Bramford to Twinstead Reinforcement

Document 8.9.3: Applicant's Responses to Second Written Questions

Final Issue A
January 2024

Planning Inspectorate Reference: EN020002

Appendix A: Construction Staff Vehicle Flow Diagram

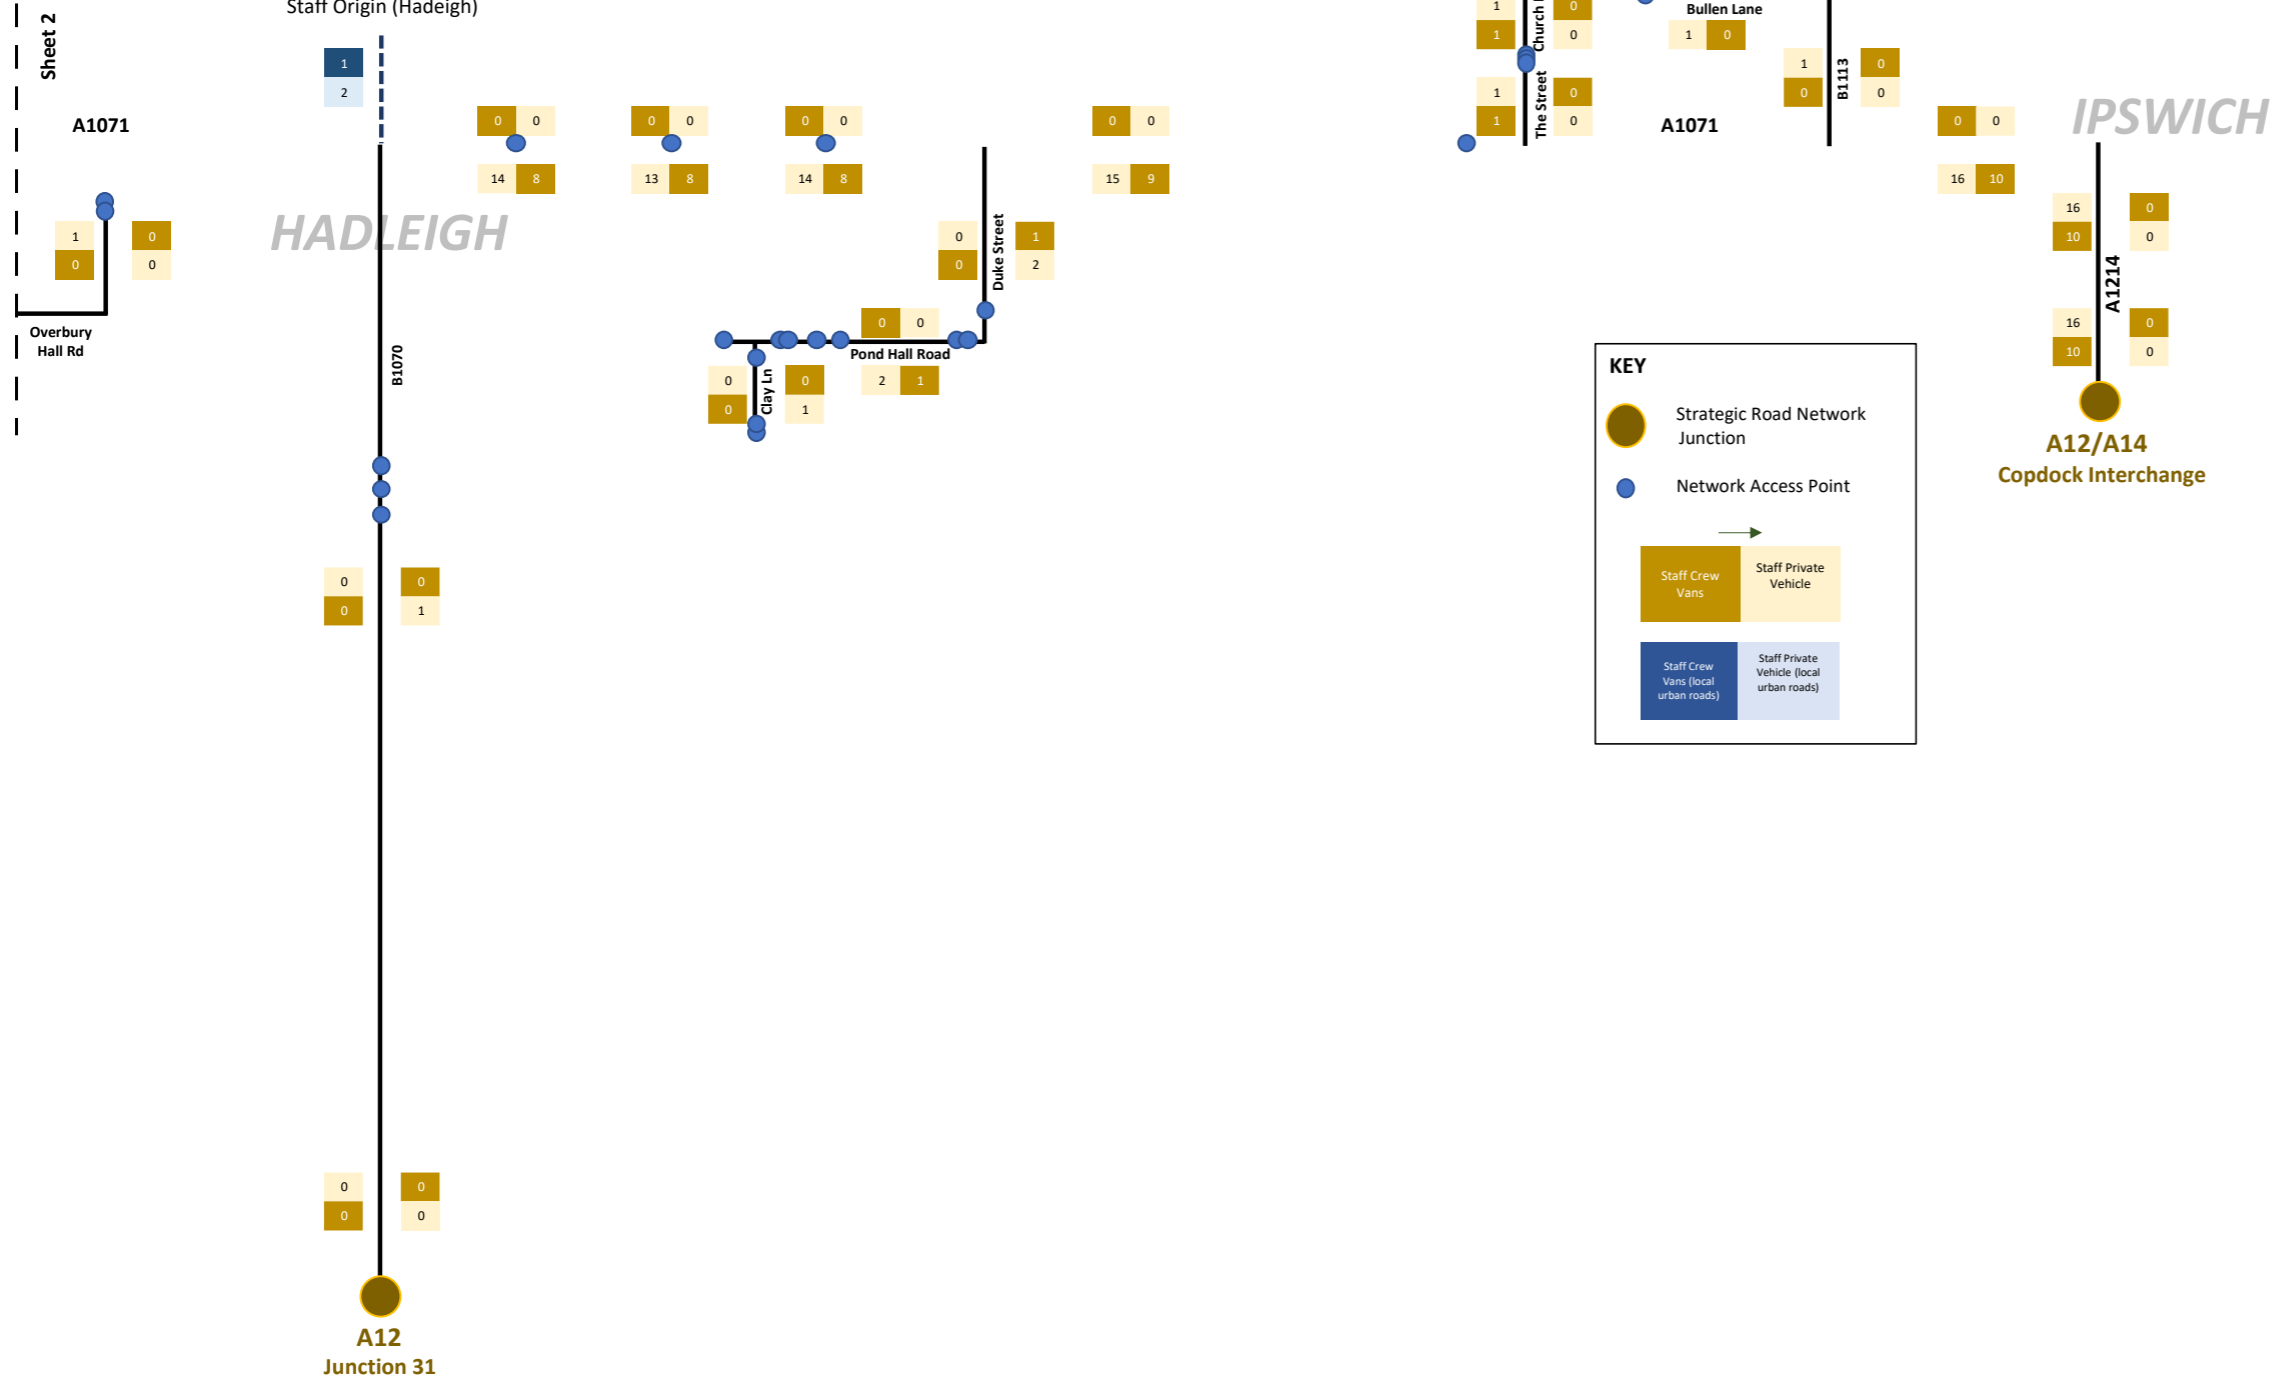
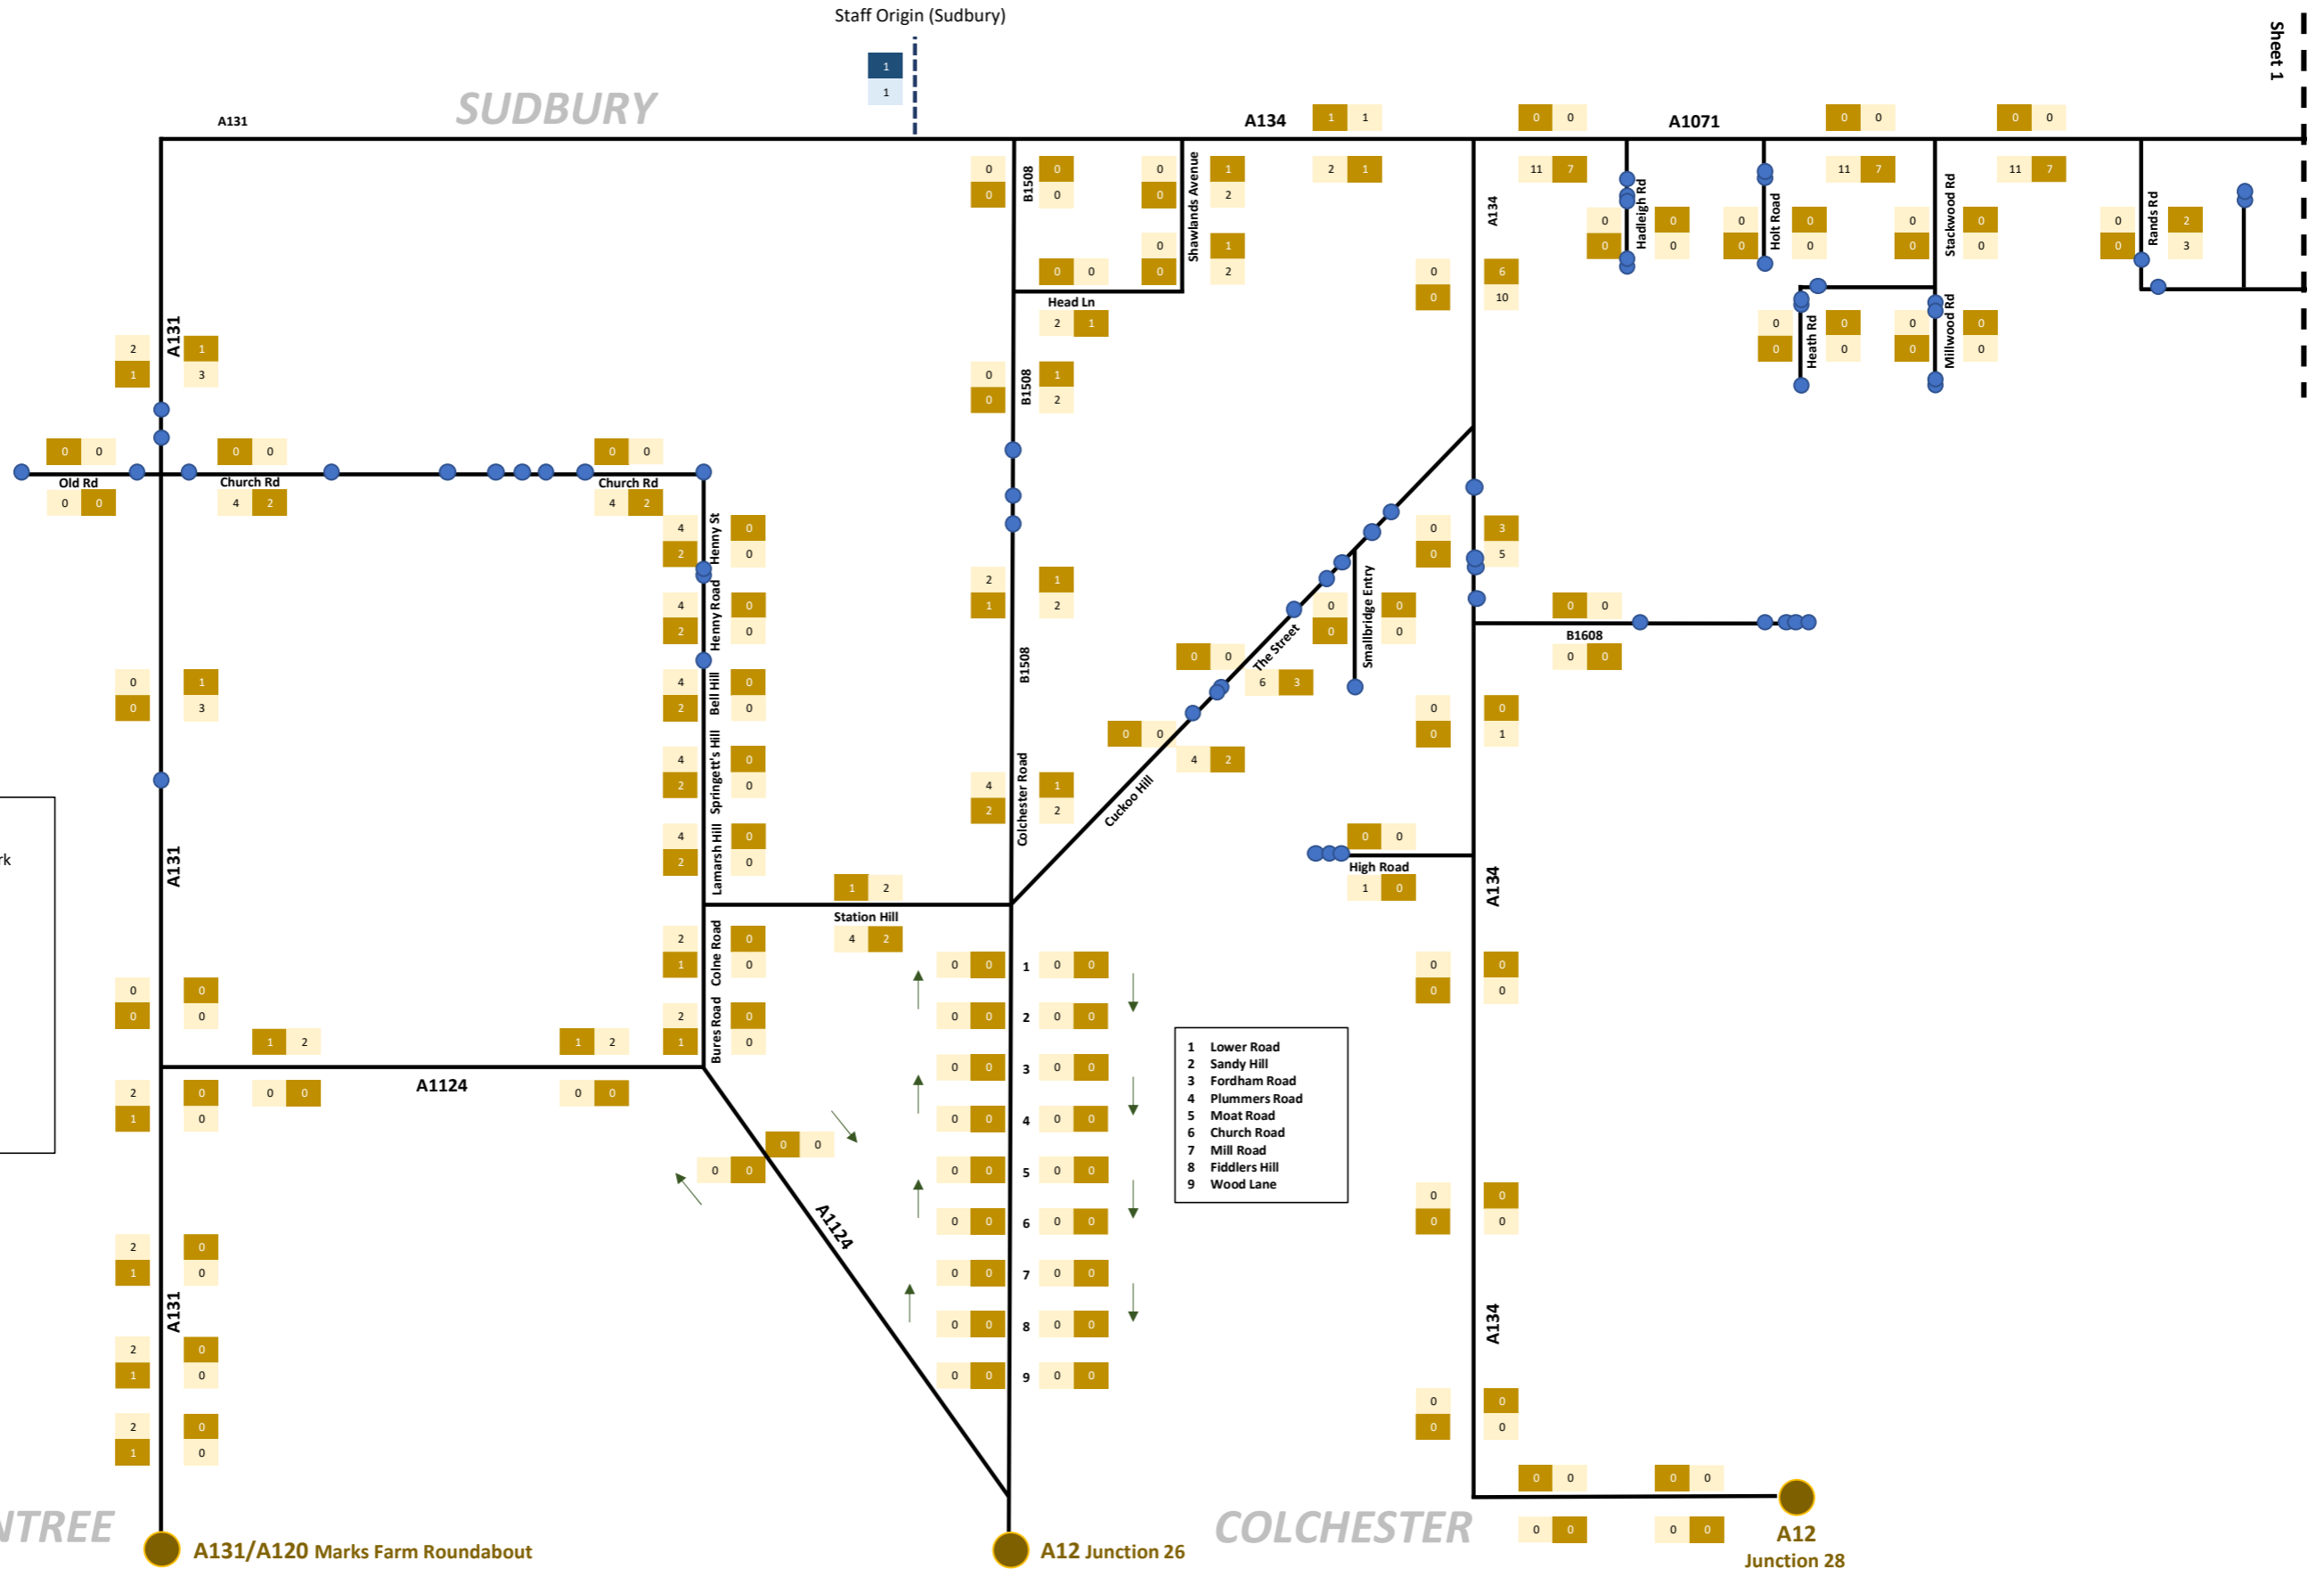
TT2.13.6	<p>The Transport Assessment ([APP-061] paragraph 6.2.12) explains that the peak daily and hourly construction vehicle forecasts are presented in the traffic flow diagrams (Figure 7) as two-way directional construction traffic flows. Can you confirm if these data include the forecast construction staff vehicle movements? If so, can you provide traffic flow diagrams to show the forecast crew minibuss movements, based on the vehicle occupancy factors to derive staff vehicle forecasts (paragraph 6.2.9 of the Transport Assessment), on the local road network in the study area during the</p>	<p>The Applicant can confirm that the data in Figure 7 in the Transport Assessment [APP-061] does include the forecast construction staff vehicle movements within the 'Light Goods Vehicle' category. Construction staff vehicle movements in the morning and evening peak hours (split by cars and crew vans in accordance with the assumptions set out in the Transport Assessment [APP-061]) are provided on the traffic flow diagrams in Appendix A: Construction staff vehicle flow diagram to this response.</p>
